## HISTORIC AND DESIGN REVIEW COMMISSION

**HDRC CASE NO:** 2019-699  
**ADDRESS:**  
911 N PINE ST  
913 N PINE ST  
915 N PINE ST  
917 N PINE ST  
**LEGAL DESCRIPTION:**  
NCB 531 (PINE AT HAYS {IDZ}), BLOCK 13 LOT 25  
NCB 531 (PINE AT HAYS {IDZ}), BLOCK 13 LOT 26  
NCB 531 (PINE AT HAYS {IDZ}), BLOCK 13 LOT 27  
NCB 531 (PINE AT HAYS {IDZ}), BLOCK 13 LOT 28  
**ZONING:** IDZ, H  
**CITY COUNCIL DIST.:** 2  
**DISTRICT:** Dignowity Hill Historic District  
**APPLICANT:** Ricardo Turrubiates/Terramark  
**OWNER:** K/T TX Holdings & T/A Apartments Inc  
**TYPE OF WORK:** Construction of a mixed-use development with multiple structures  
**APPLICATION RECEIVED:** June 26, 2020  
**60-DAY REVIEW:** Not applicable due to City Council Emergency Orders  
**CASE MANAGER:** Edward Hall  
**REQUEST:**

HDRC Case #: 2019-699

# Pine Street Studios

**MASTER  
SITE PLAN**

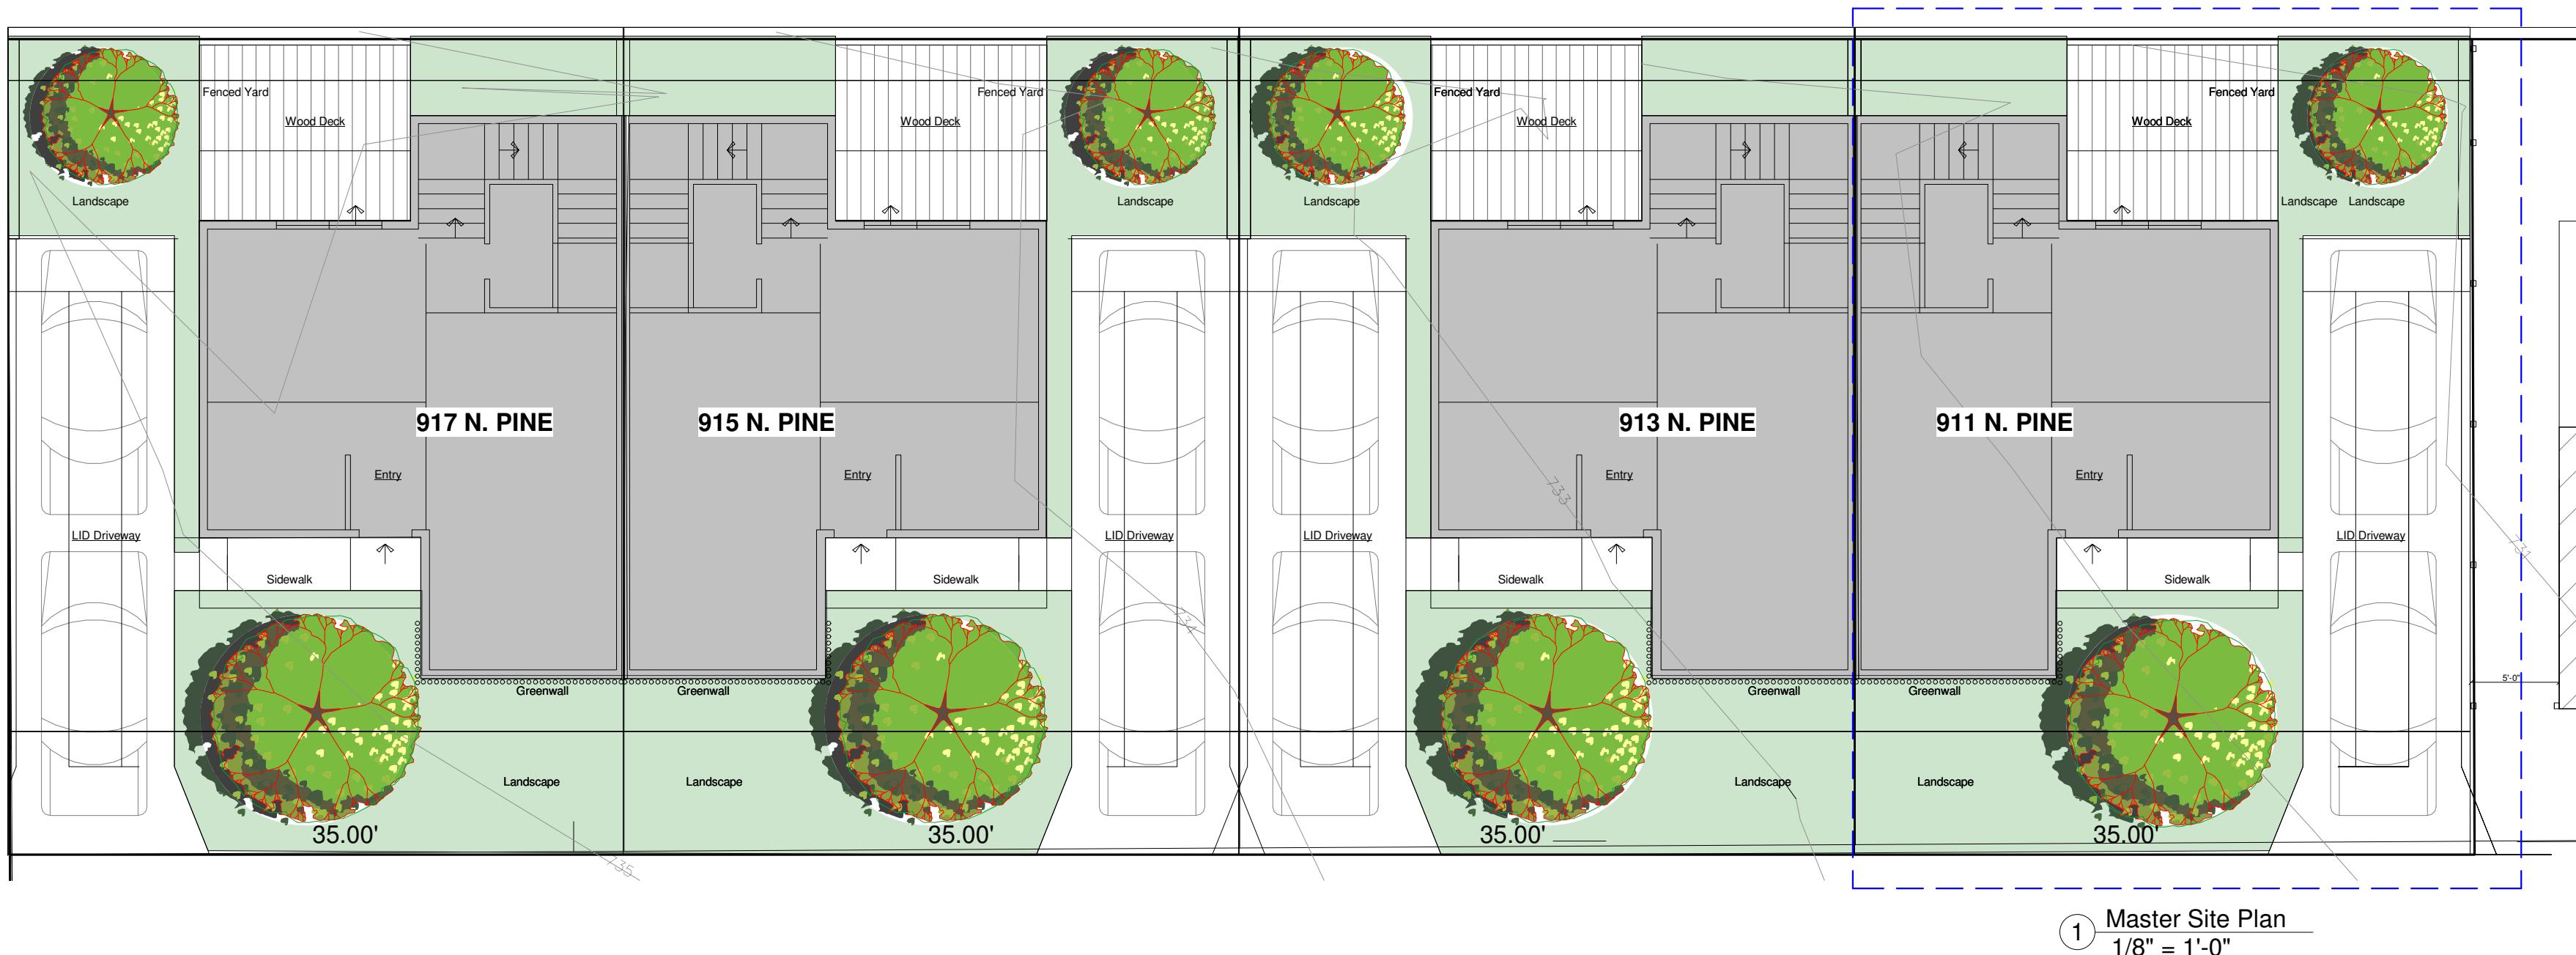
- p. SITE ELEMENTS (Driveways) – The applicant has incorporated driveways for each structure that terminate to the side of the proposed new construction. The Guidelines for Site Elements 7.A. notes that front yard parking should not be added into the front yard setbacks. Generally, the proposed driveway locations are appropriate and consistent with the Guidelines; however, as proposed, the driveways feature a width that is inconsistent with the Guidelines. The applicant should submit detailed site documents regarding driveways that clearly note materials and overall widths at the driveway approach and apron. Additionally, driveways on separate lots should be separated, and should not read as a continuous driveway condition.

- q. LANDSCAPING – The applicant has noted landscaping materials on the proposed site plan. As noted in the above findings, staff finds that driveways should be consistent with the Guidelines and that driveways on separate lots should read as such.

- vii. That the proposed driveways be separated at lot lines, as noted in findings p and q.
- viii. That the applicant identify the location of mechanical equipment, and screen it from view from the public right of way.

**FRONT &  
RIGHT ELEV.**

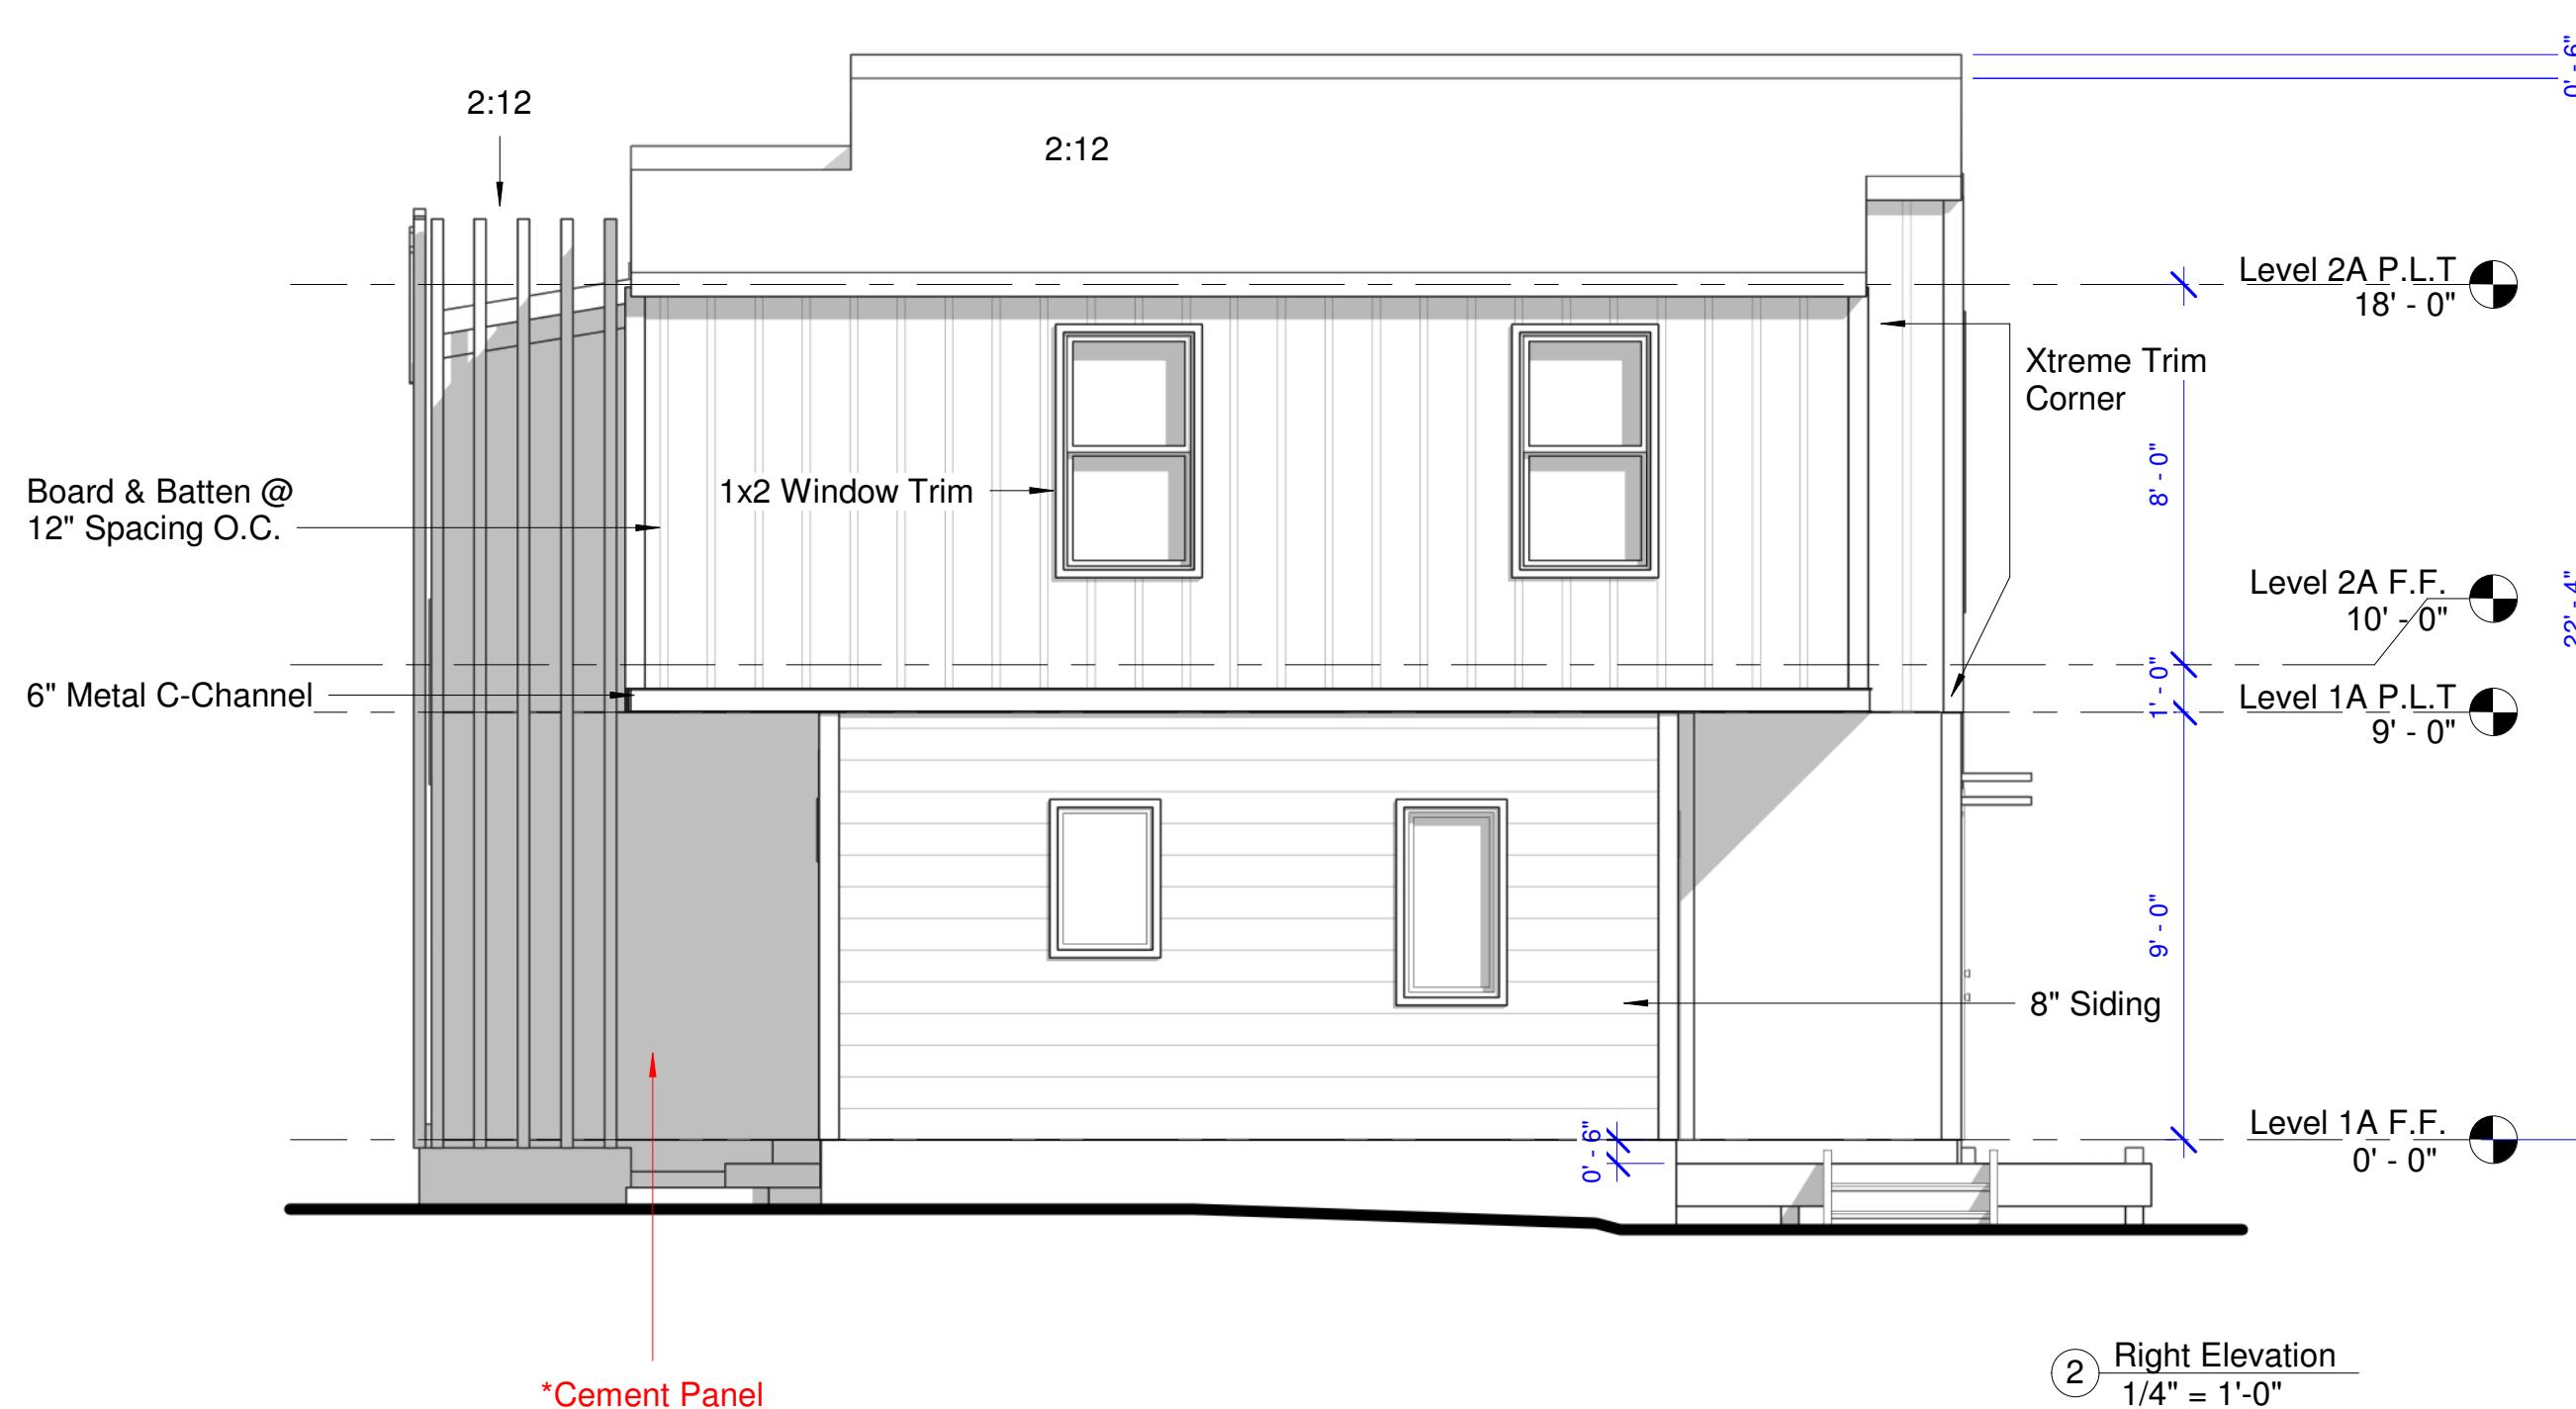
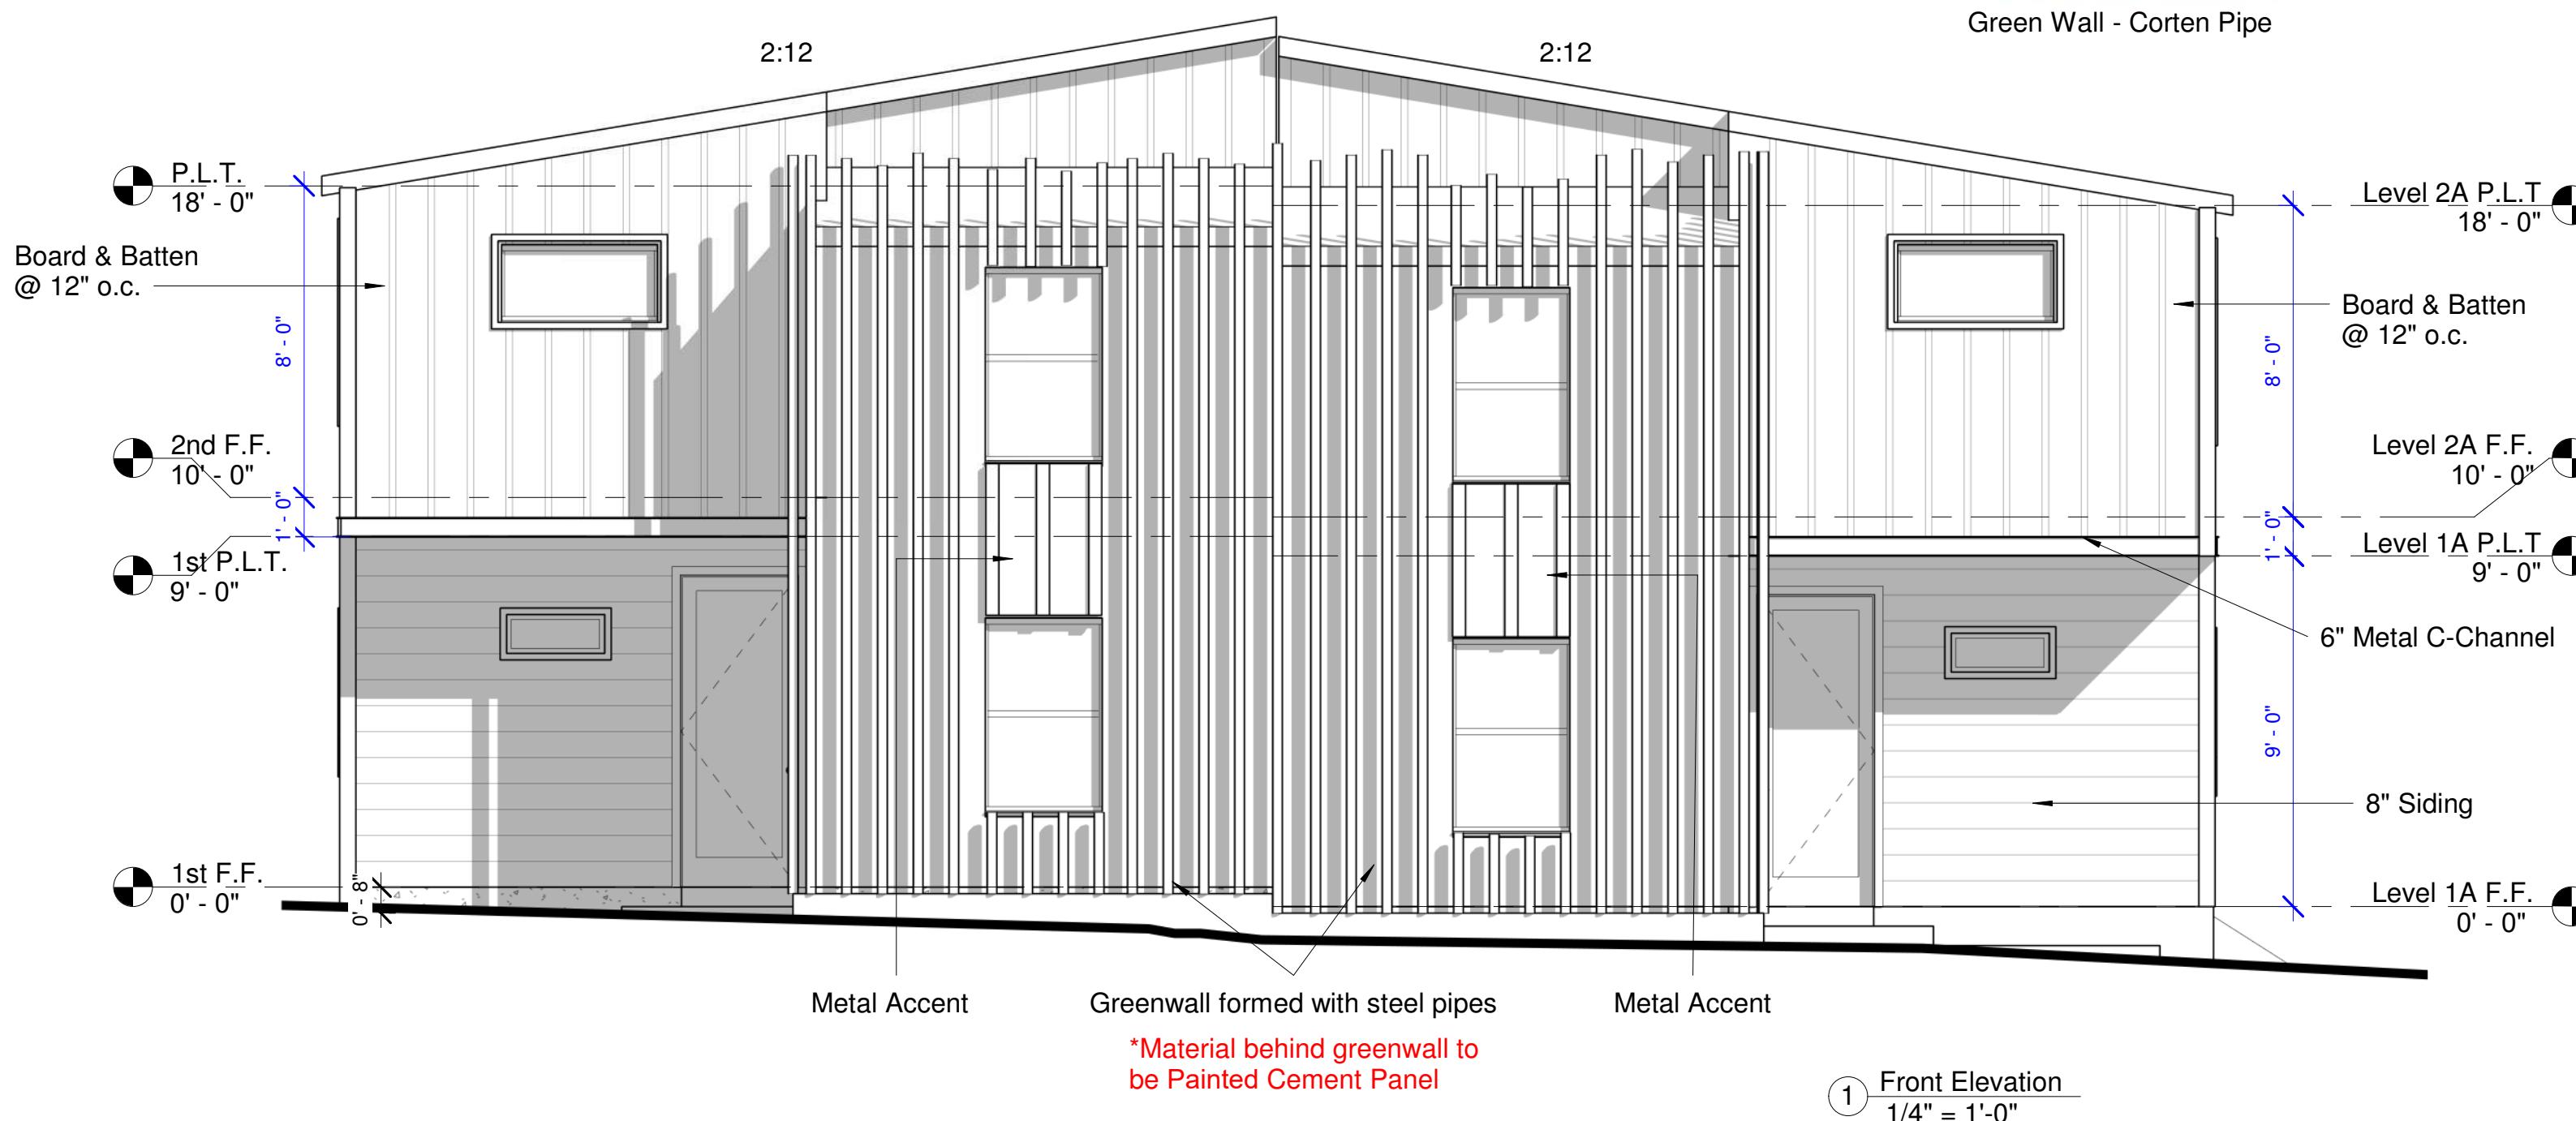
- k. ROOF FORMS – The Guidelines for New Construction 2.B.i. notes that roof forms of new construction should feature pitches, overhangs and orientations that are consistent with those found historically on the block. Per the submitted application documents, the applicant has proposed roof forms with very low slopes. Generally, this is inconsistent with roof forms found historically throughout the district, and is inconsistent with the Guidelines.

- l. WINDOW & DOOR OPENINGS – The Guidelines for New Construction 2.B.i. notes that windows and door openings featuring similar proportions to those of historic structures in the vicinity should be used. Per the submitted application documents, the applicant has proposed windows openings that feature contemporary profiles, and windows that feature fixed sashes. Staff finds that both window openings and window profiles should be consistent with the Guidelines, and historic examples found throughout the Dignowity Hill Historic District.

- m. MATERIALS – The applicant has proposed materials that include composite board and batten siding, exposed steel C-channel members, a metal façade application consisting of steel pipes and painted cement panel walls. Staff finds the proposed materials to be inconsistent with the historic examples found throughout the district, and inconsistent with the Guidelines. Staff finds that materials that are consistent with the Guidelines should be used.

JF: The north façade should be softened with more traditional elements (windows). East and West facades should align with each other vertically (as found historically within the district).

- iii. That the applicant propose roof forms that are consistent with the Guidelines and that are consistent with those found historically within the District as noted in finding k.

- iv. That the applicant implement window and door openings that are consistent with the Guidelines those found historically within the district as noted in finding l.

- v. That the applicant propose materials that are consistent with the Guidelines and those found historically within the district as noted in finding m.
